EXPERT ANALYSIS OF PROPOSED BORDER WALL AND BUOY SYSTEM ON THE RIO GRANDE RIVER IN WEBB AND ZAPATA COUNTIES, TEXAS, USA

PREPARED FOR: Rio Grande International Study Center
PREPARED BY: Mark R. Tompkins, PE, Ph.D, FlowWest
DATE: 02/10/2026

FIGURE 3: MAPPED FLOOD ZONES AND CRITICAL INFRASTRUCTURE ALONG THE RIO GRANDE RIVER IN WEBB COUNTY.

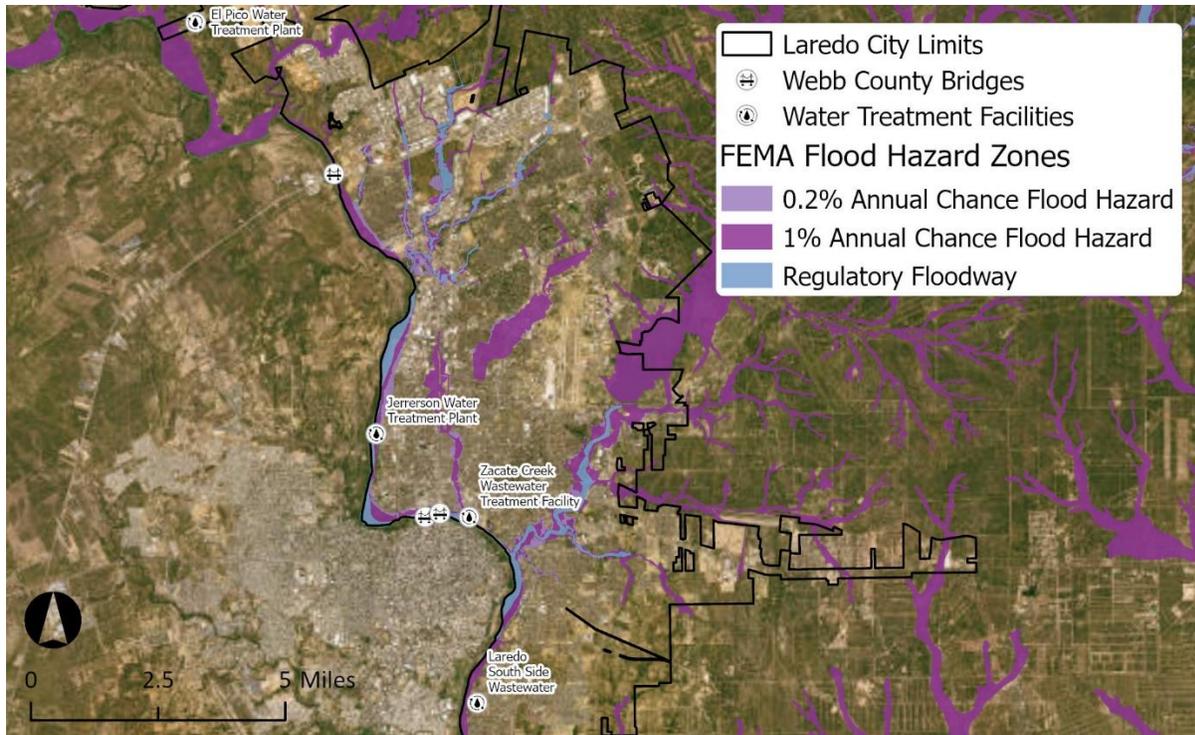
Figure 3 and Figure 4 show the existing flood hazard zones along the Rio Grande for Webb County. In addition, these figures show the locations of bridges, water treatment plants, and wastewater treatment plants. All of this critical infrastructure is in the existing flood hazard zone, meaning that it will be inundated during extreme events. Figure 5 shows how the existing flood control system is already stressed during high flows. The higher flows in the 2010 image in Figure 5 clearly inundate areas well beyond the river edge, including areas where the new wall is proposed. The proposed wall and buoy system will greatly exacerbate the existing hydraulic risk by raising water levels and redirecting flows into the cleared wall area, resulting in more rapid and extensive erosion of the existing flood control system, and more frequent overtopping of the flood control system. The hydraulic risks of the proposed wall and buoy system are dramatic just considering the presence of the new wall, patrol area, and buoys. However, debris loading (discussed below) will greatly compound this risk and almost certainly result in devastating system failures caused by the hydraulic alterations to the Rio Grande that result from the proposed project.

FIGURE 6: HISTORICAL LOCATIONS OF SIGNIFICANT CHANNEL CHANGE ON THE RIO GRANDE RIVER ALONG WEBB COUNTY.

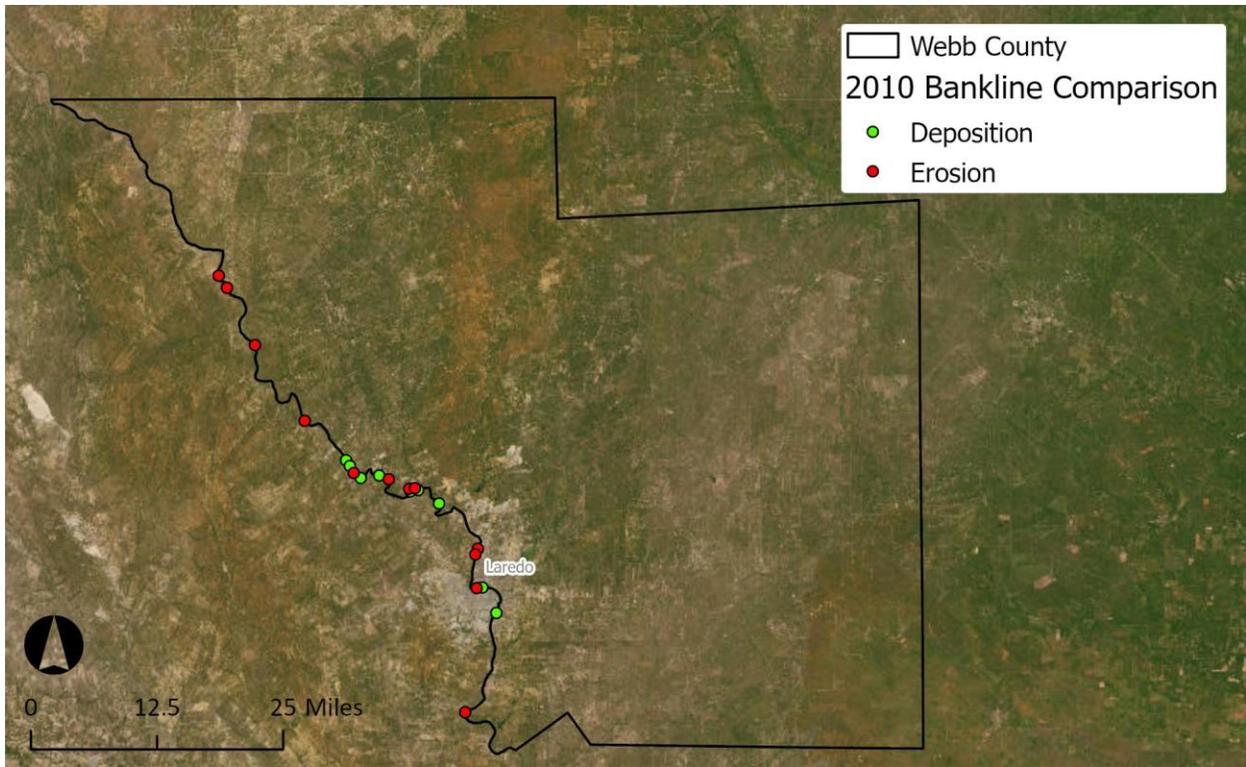
Figure 6 shows locations of significant historical channel change that has occurred without the proposed project in place. This includes channel migration, bank erosion, and in-channel island formation. Figure 7 and Figure 8 show major island growth and bank erosion, respectively, that has occurred in Laredo. It is extremely important to note that this change has occurred over only fourteen years, which is an extremely small increment of time in the evolution of a river like the Rio Grande. The proposed wall and buoy system will greatly increase the geomorphic risk along the river, with accelerated evolution along the U.S. side. Similar to hydraulic risk, the geomorphic risks will be exacerbated during high flows when debris loading focuses the erosion and scour onto bare channel banks and causes rapid and extensive channel migration along the U.S. bank of the river.
